MOUNT OWEN CONTINUED OPERATIONS PROJECT

REPORT B
Response to Department of the
Environment Submission

Prepared by
Umwelt (Australia) Pty Limited

FIGURE 2.20
Ecological Communities in Area
of Predicted Drawdown
(2030 + 1SD)

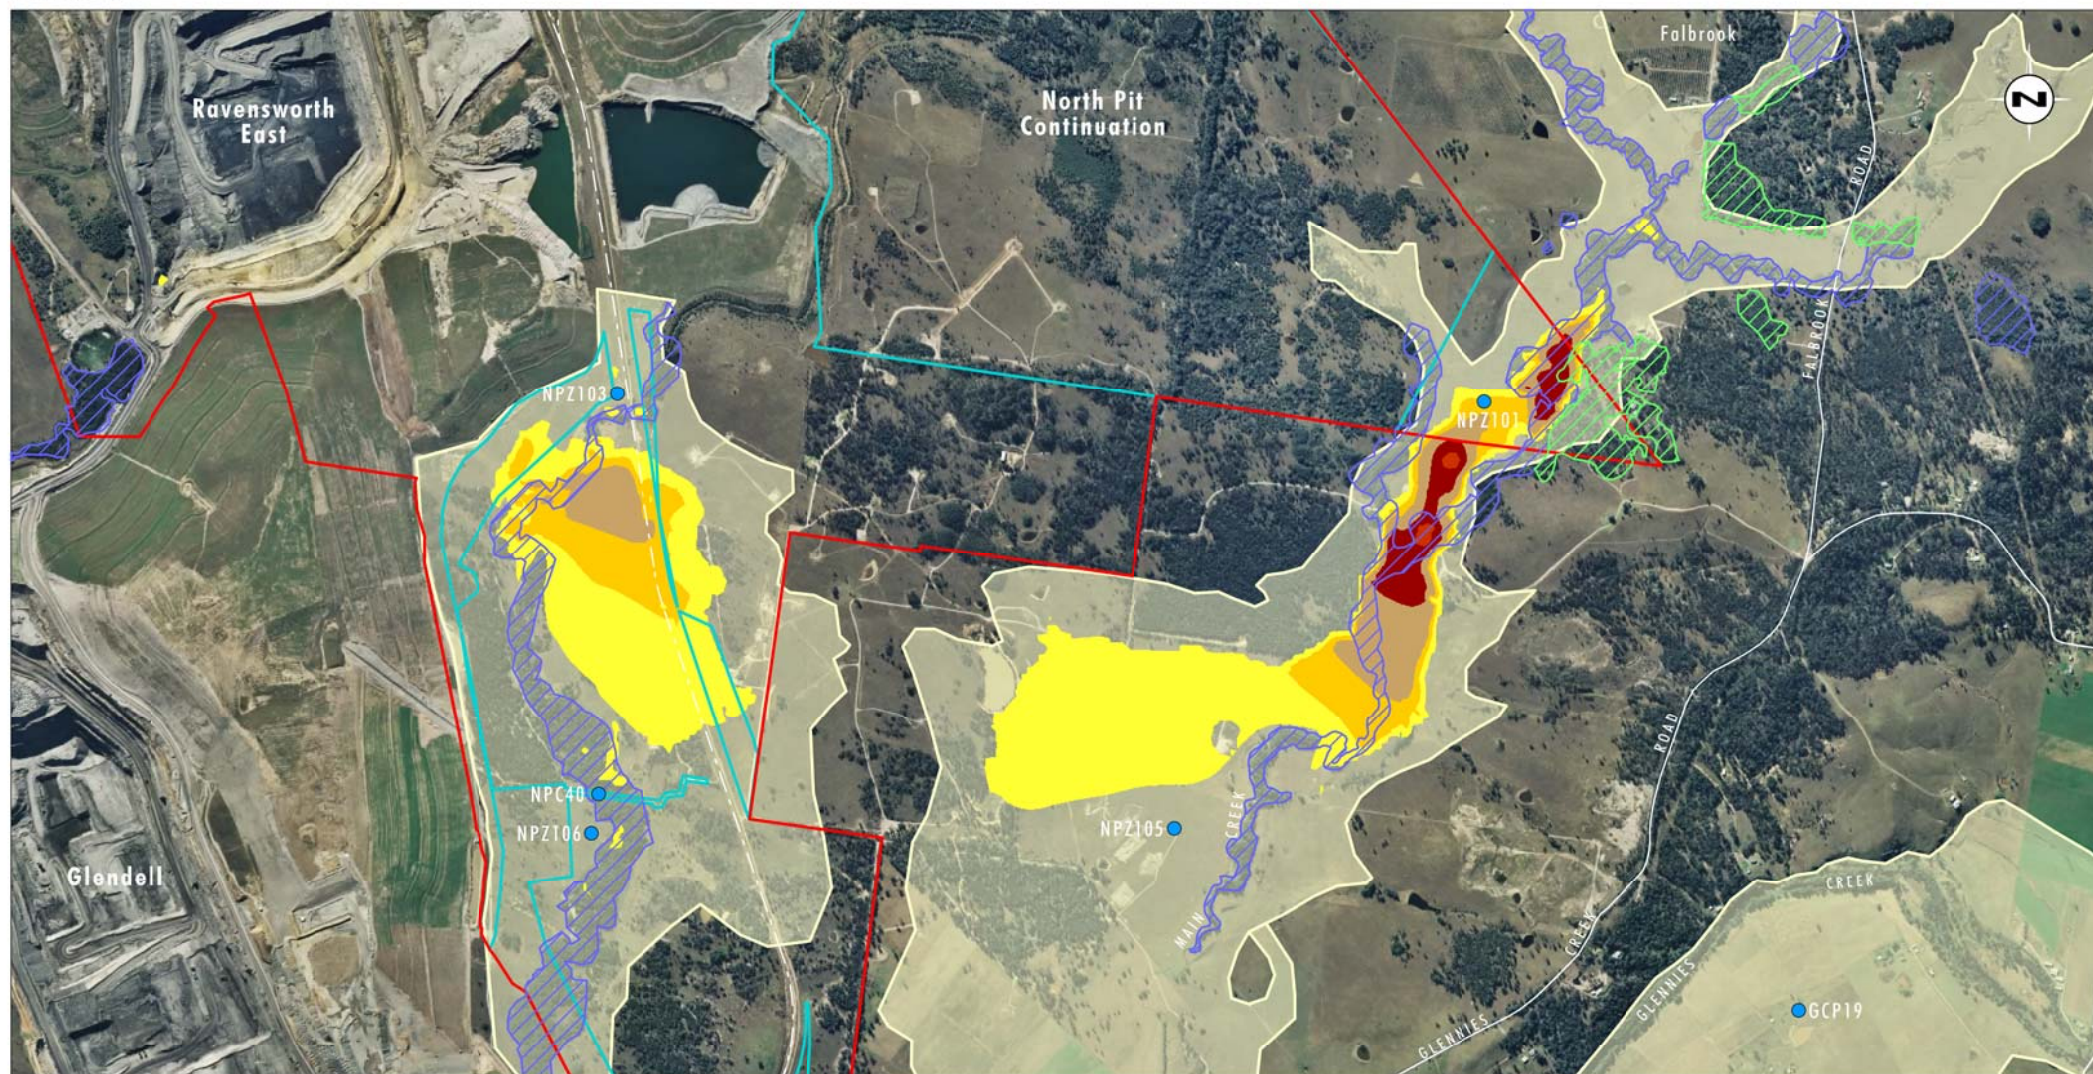
The EIS states (App 10, p 92) that no GDEs are associated with Yorks Creek and Swamp Creek. However, the riparian zones of these watercourses are mapped as containing the Central Hunter Swamp Oak Forest which is considered to be a GDE (EIS, App 11, Figure 4.1). The proponent has not mapped or estimated the area inhabited by groundwater dependent riparian vegetation outside of the project area, including within the zone of predicted alluvial impact and downstream of the proposed project area. [Paragraph 8]

Mapped vegetation types and the location of standpipes recently installed in the alluvium in the areas of Main Creek and Bettys Creek where there are predicted drawdown impacts are shown on **Figure 2.20** with the extent of the predicted potential maximum drawdown (2030 Median + 1SD).

As can be seen in **Figure 2.20**, approximately 1 kilometre of the Central Hunter Swamp Oak Forest along Main Creek is located over the area of proposed drawdown of more than 1 metre (i.e. greater drawdown than has been observed in natural fluctuations over the 12 month period to April 2015).

Figure 11 – Glennies Creek – Predicted Impacts

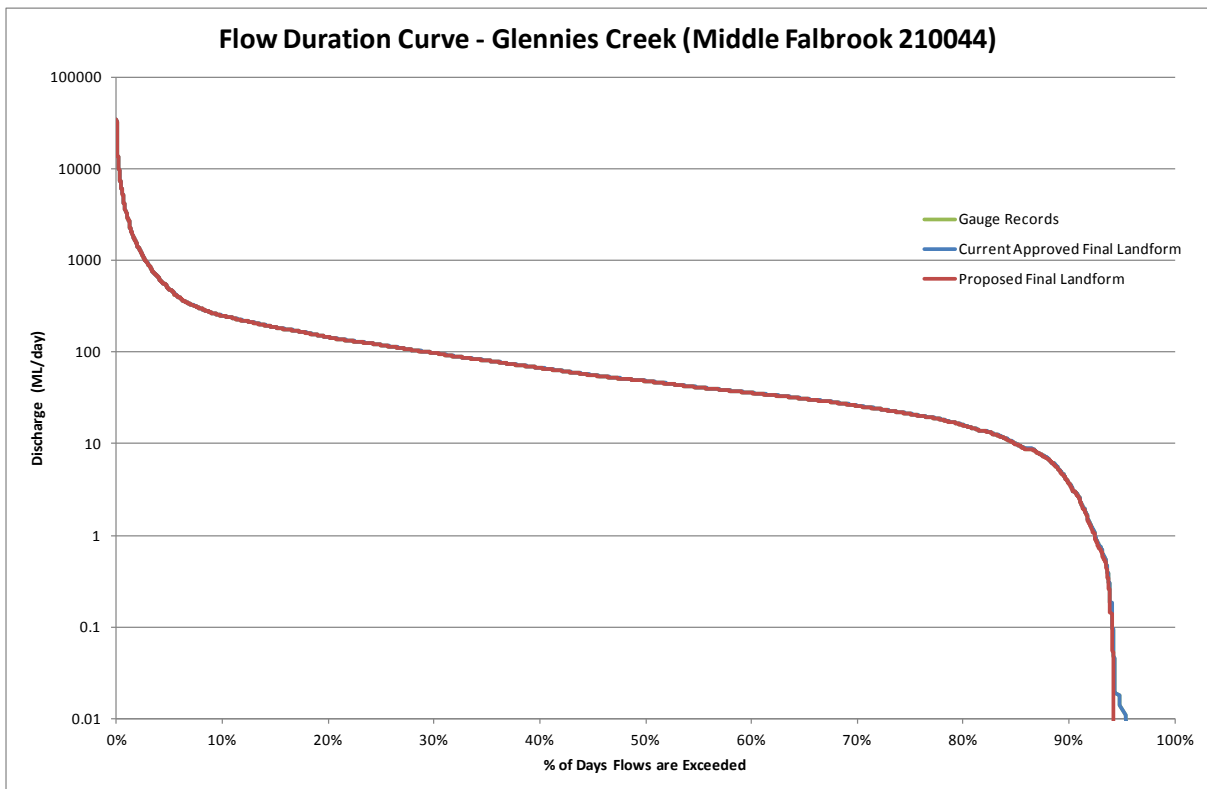
The EIS states (App 10, p 92) that no GDEs are associated with Yorks Creek and Swamp Creek. However, the riparian zones of these watercourses are mapped as containing the Central Hunter Swamp Oak Forest which is considered to be a GDE (EIS, App 11, Figure 4.1). The proponent has not mapped or estimated the area inhabited by groundwater dependent riparian vegetation outside of the project area, including within the zone of predicted alluvial impact and downstream of the proposed project area. [Paragraph 8]

The flow duration curve indicates that the predicted flow impacts with the Project show little variation to both the gauge record and the current approved final landform. As shown on **Figure 11** the Project will impact not impact on baseflows in Glennies Creek due to the highly regulated processes within Glennies Creek. The mapping of the extent or location of pools or assessment of habitat value, in and adjacent to Glennies Creek is therefore not considered to be warranted.
